EAST ROCKVILLE DESIGN GUIDELINES  
Rockville, Md.

March 12, 2019  
**Draft for Discussion**

**DRAFT FOR DISCUSSION v2**

**Parking, Garages & Pavement (Issue 4)**

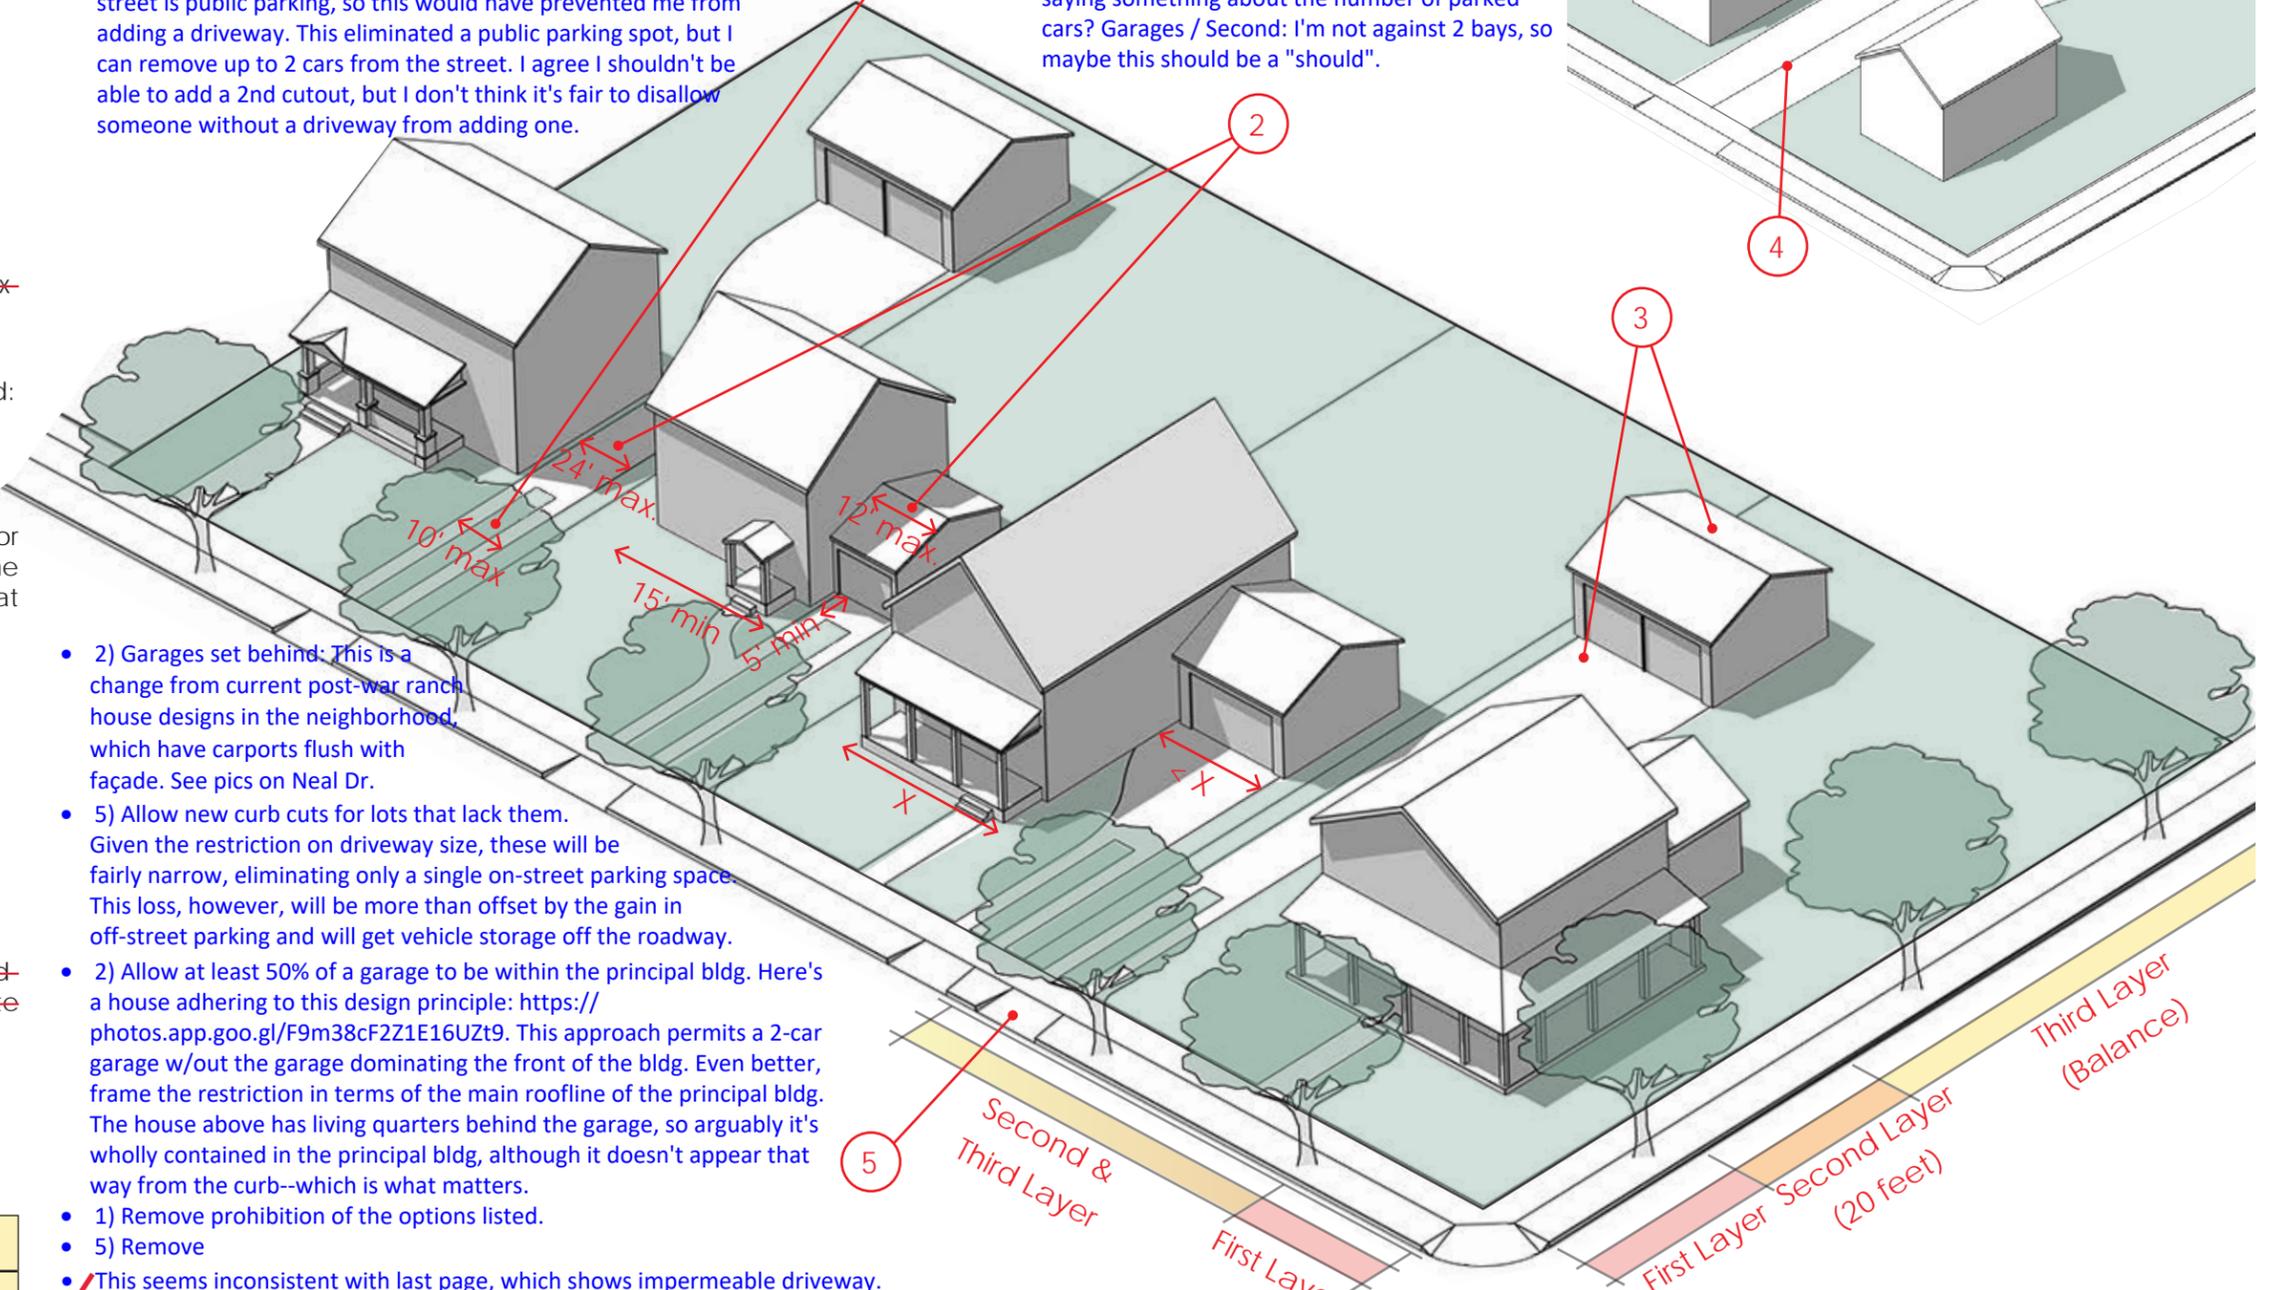
- 1) Parking excluded: May be misunderstanding, but this makes me think that I wouldn't be able to park in my driveway (almost all the driveways on my street end at the front of the house, so that's the only place I can park except for the street). Also, the 10' differs from the 12' in the chart at the bottom (I think).
- 5) I don't think I like this: When I bought my house a few years ago, there was no driveway nor curb cut-out. And the whole street is public parking, so this would have prevented me from adding a driveway. This eliminated a public parking spot, but I can remove up to 2 cars from the street. I agree I shouldn't be able to add a 2nd cutout, but I don't think it's fair to disallow someone without a driveway from adding one.

- Parked cars / First: See #1 above - I don't think that's feasible on my street. Parked cars / Second: "50% of building width" - Does this mean that the width of the area that cars can park is no wider than 50% of the principal buildings width? Or is it saying something about the number of parked cars? Garages / Second: I'm not against 2 bays, so maybe this should be a "should".

- 2) Garages set behind: This is a change from current post-war ranch house designs in the neighborhood, which have carports flush with façade. See pics on Neal Dr.

- 5) Allow new curb cuts for lots that lack them. Given the restriction on driveway size, these will be fairly narrow, eliminating only a single on-street parking space. This loss, however, will be more than offset by the gain in off-street parking and will get vehicle storage off the roadway.

- 2) Allow at least 50% of a garage to be within the principal bldg. Here's a house adhering to this design principle: <https://photos.app.goo.gl/F9m38cF2Z1E16UZt9>. This approach permits a 2-car garage w/out the garage dominating the front of the bldg. Even better, frame the restriction in terms of the main roofline of the principal bldg. The house above has living quarters behind the garage, so arguably it's wholly contained in the principal bldg, although it doesn't appear that way from the curb--which is what matters.

- 1) Remove prohibition of the options listed.
- 5) Remove
- This seems inconsistent with last page, which shows impermeable driveway.
- 6) Add prohibition of parking large recreational vehicles, boats, and non-functional vehicles in any on-street parking or in the First Layer.

- 1) a nice goal to not have the front yards be full of cars. However, it seems close to impossible to enforce and/or a potential frustration for homeowners

- 2) last bullet: After the community meeting, we have specifically been looking for examples within the neighborhood. We do not believe a garage is a block in the "front porch environment" if placed equal or 5 feet in front of primary building either. This creates a need for more driveway length which is almost more bothersome.

- 5) I do not think this is a restriction that is necessary street parking in many areas of the neighborhood is no problem. Why limit driveways? that seems to be a key character of this neighborhood.

- 5) What flexibility or consideration is given to corner lots and/or extremely wide lots? Could there be a limit on the width of the driveway depending on the amount of primary and secondary frontage? Could there be a limit of 1 driveway on each: primary frontage, and secondary frontage. This most certainly is not a SHALL. perhaps a should. or none at all.

**Additions (Issue 5)**

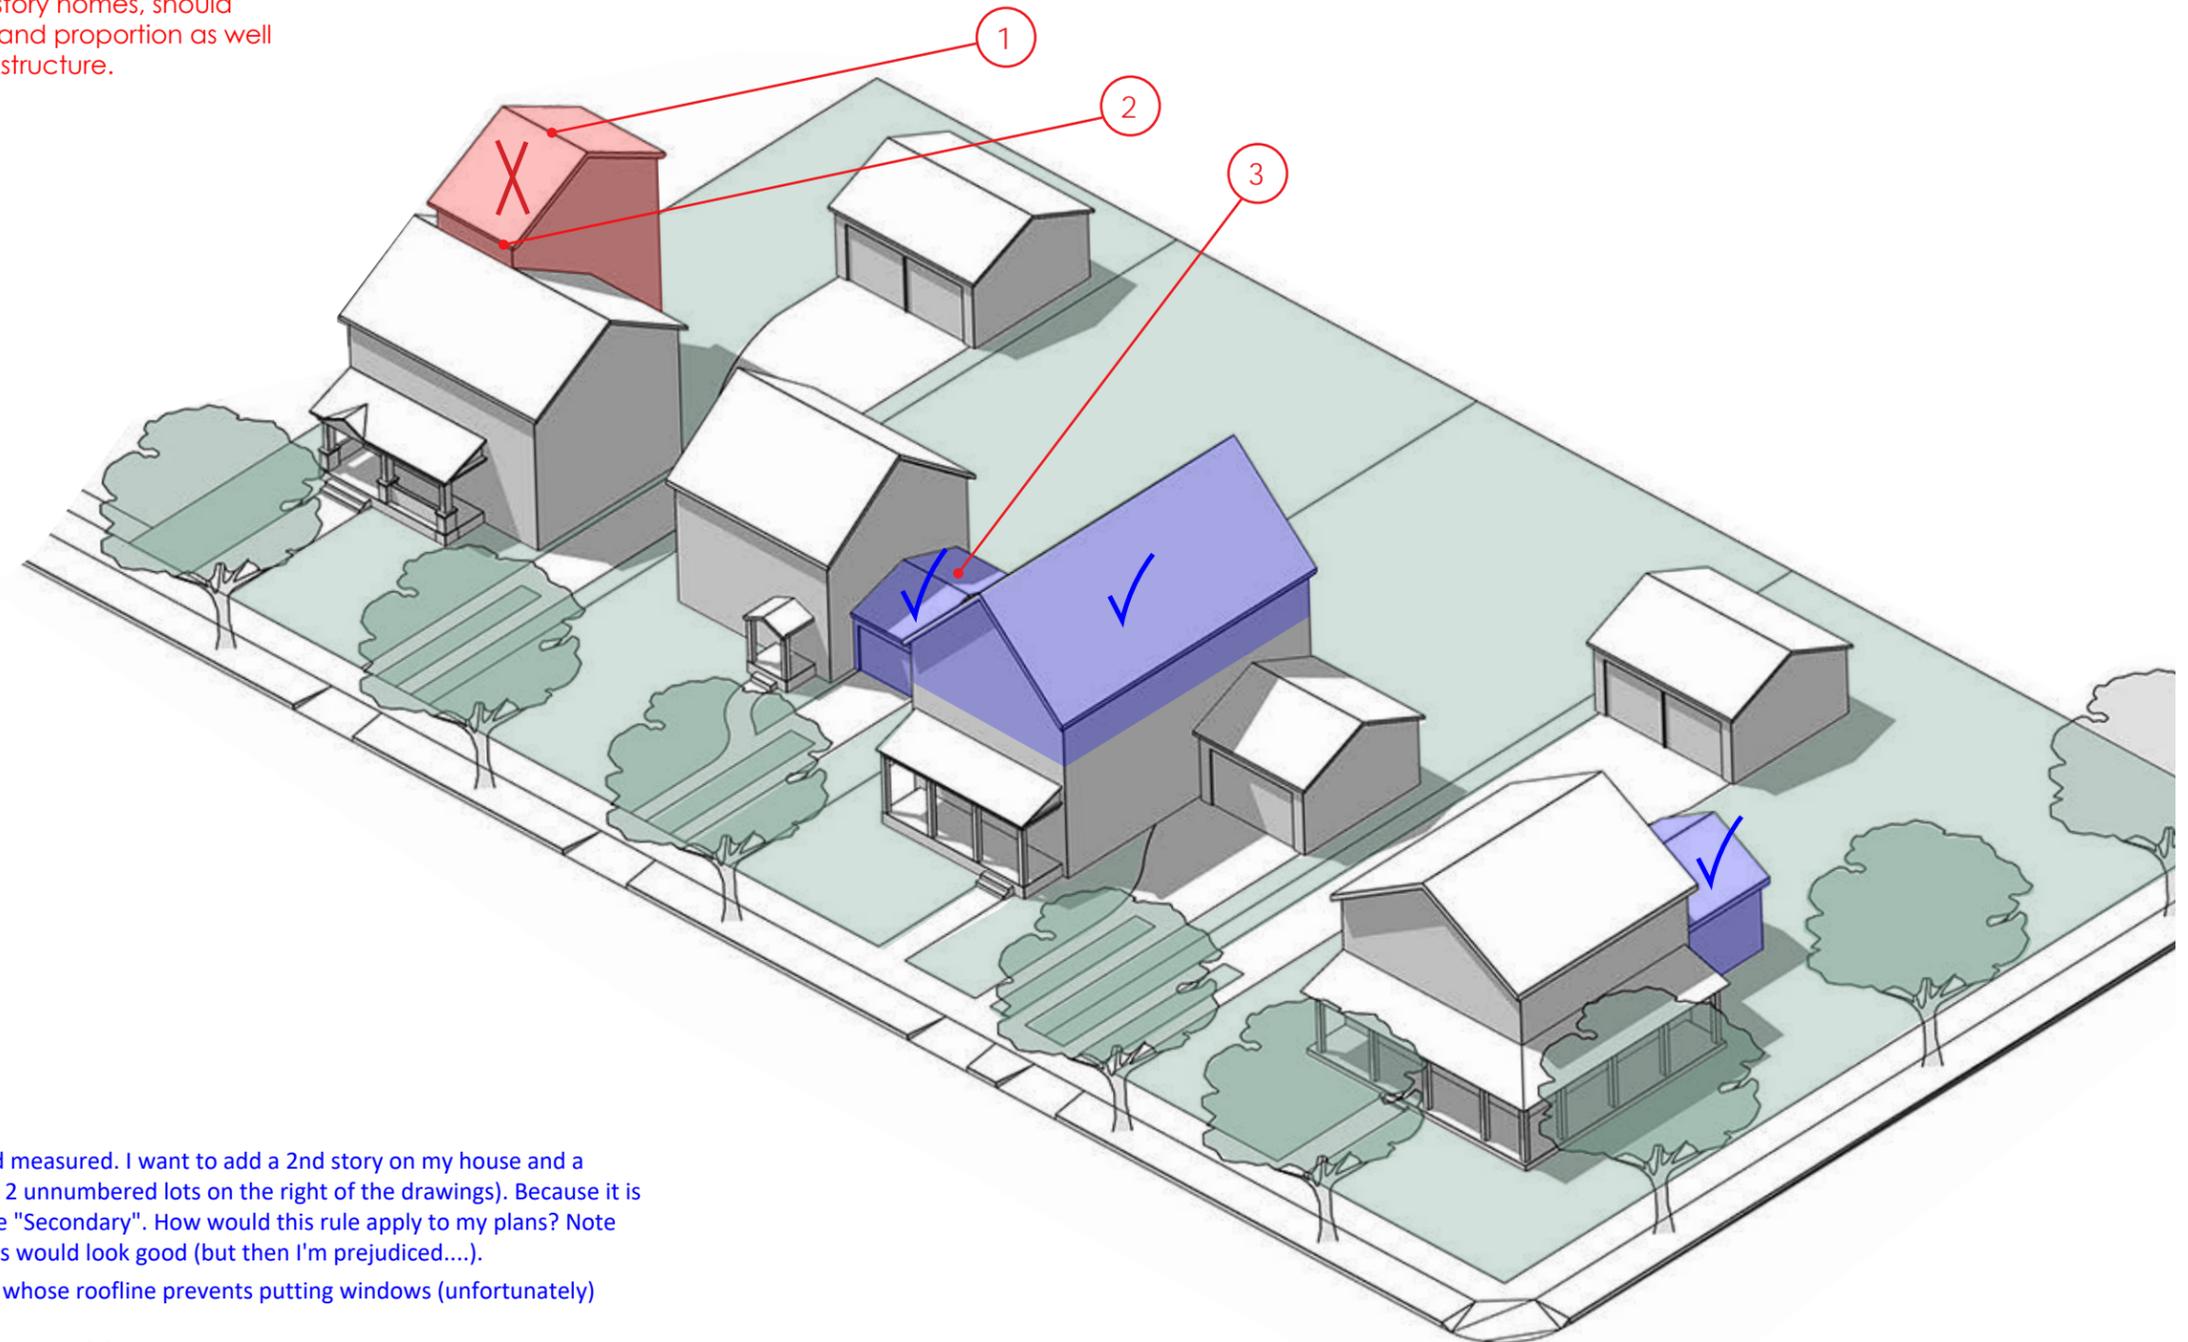
- 3) Para 1: I don't understand how that would be implemented and measured. I want to add a 2nd story on my house and a single story extension on the back (so kind of a combination of the 2 unnumbered lots on the right of the drawings). Because it is more than the size of the current house, I'm thinking it wouldn't be "Secondary". How would this rule apply to my plans? Note that my current house is small (640 sq ft), so I \*think\* the additions would look good (but then I'm prejudiced....).

- 3) Para 2: I'm a little uneasy here, too. My house has a front porch whose roofline prevents putting windows (unfortunately) above the windows on the first floor (on the front of the house).

- I mostly support this proposal if it is established as flexible guidelines, not rigid rules.
- 3) Change shall to should in the last 2 paragraphs.
- 1) Change rule from shall to should.

- 3) This may be a hardship, especially to some of the smaller homes.
- 3) last point: This sounds like a Should, not a Shall. - due to the "alternatively" section.

- 3) 3rd point: Façades of an additional story "should" instead of "shall". This should be an issue that is encouraged. Fine as is, too.

**Building Massing & Scale (Issue 6)**

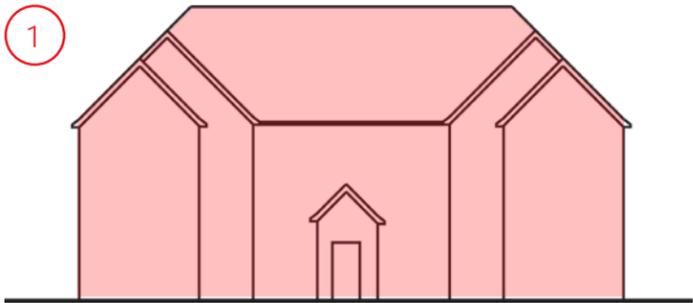
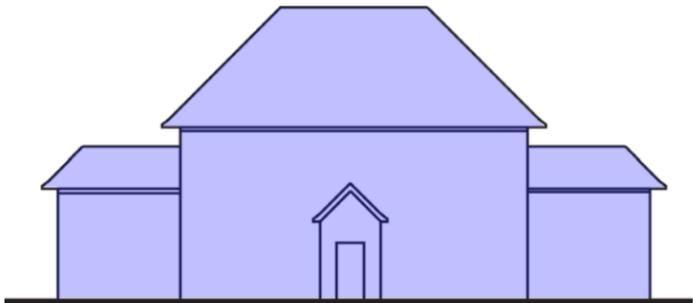
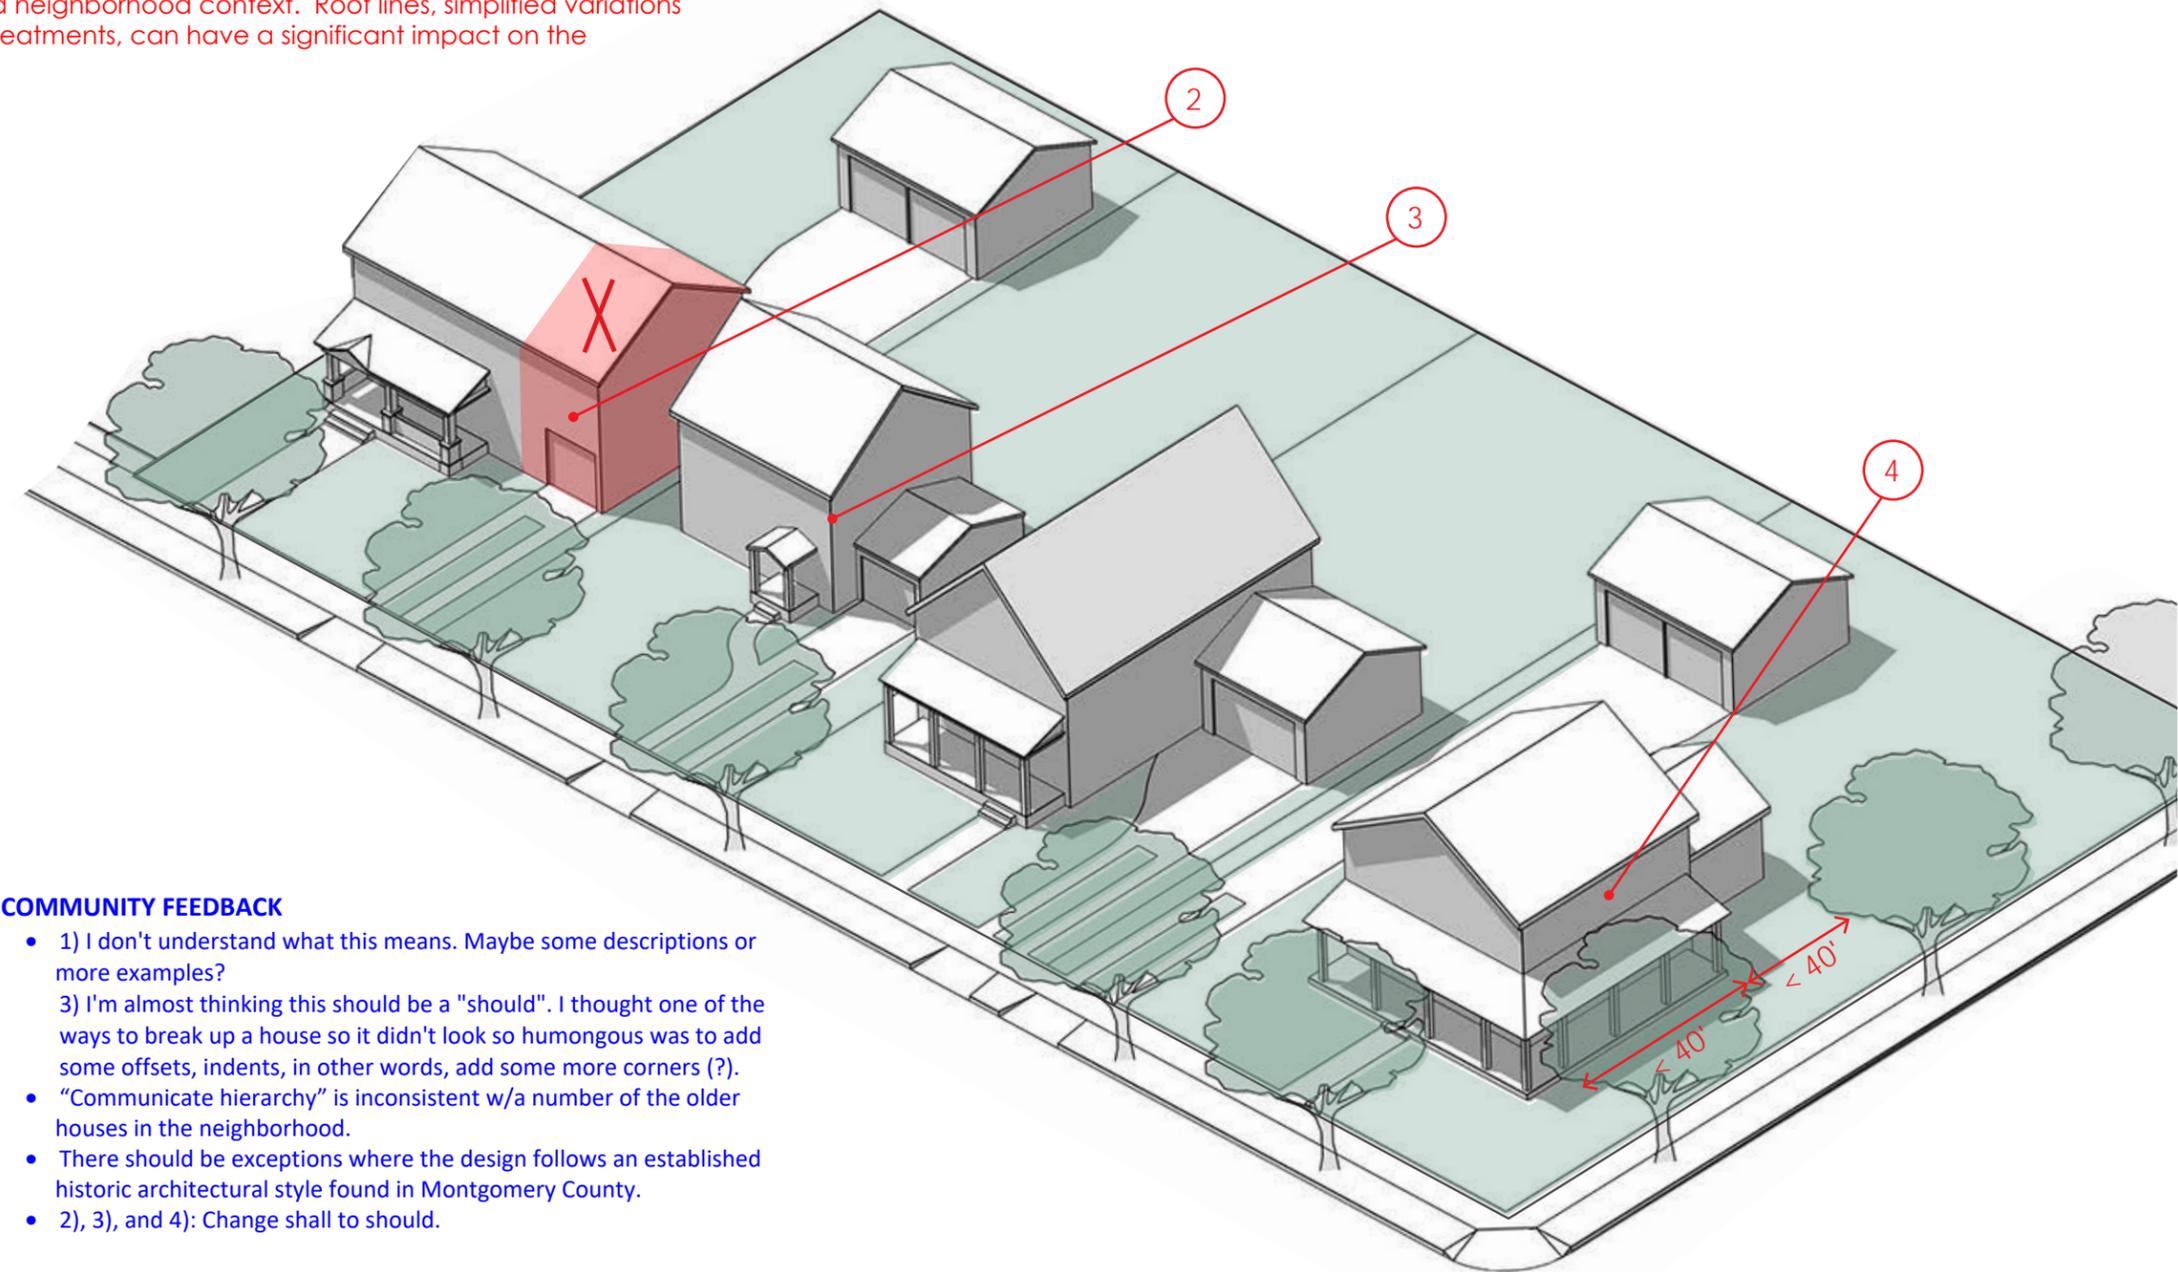
- 1) I don't understand what this means. Maybe some descriptions or more examples?
- 3) I'm almost thinking this should be a "should". I thought one of the ways to break up a house so it didn't look so humongous was to add some offsets, indents, in other words, add some more corners (?).
- "Communicate hierarchy" is inconsistent w/a number of the older houses in the neighborhood.
- There should be exceptions where the design follows an established historic architectural style found in Montgomery County.
- 2), 3), and 4): Change shall to should.
